URGENT MEDICAL DEVICE CORRECTION

September 10, 2019

Affected Product: ROSA Brain 3.0

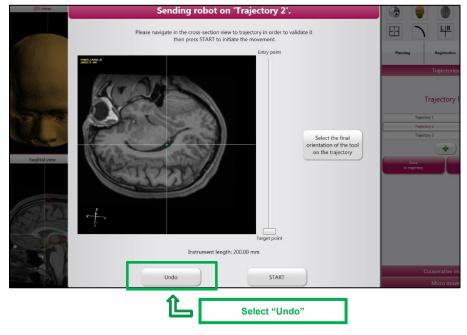
- 1. Once you select the instrument holder, if you would like to Undo your action :
 - DO NOT select "Undo"
 - Select "OK"

2. In the next frame, select Undo

ATTACHMENT 2 Detailed sequence of events

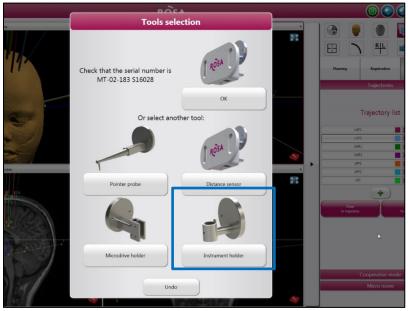
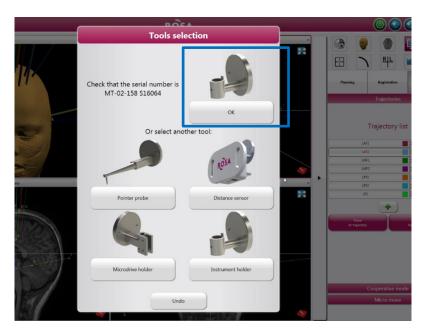
- 1. Use of the optical distance sensor during guidance mode, e.g. to mark entry points on the patient's head with a skin marker
- 2. Choosing drive to a trajectory and selection of the instrument holder

- 3. Installation of the instrument holder on the robot arm
- 4. Clicking undo on the tool installation frame

5. Choosing drive to a trajectory, then re-selection of the current instrument holder and drive to the trajectory

If the above listed steps are performed, the instrument holder may be sent on a trajectory that is not within the intended target.
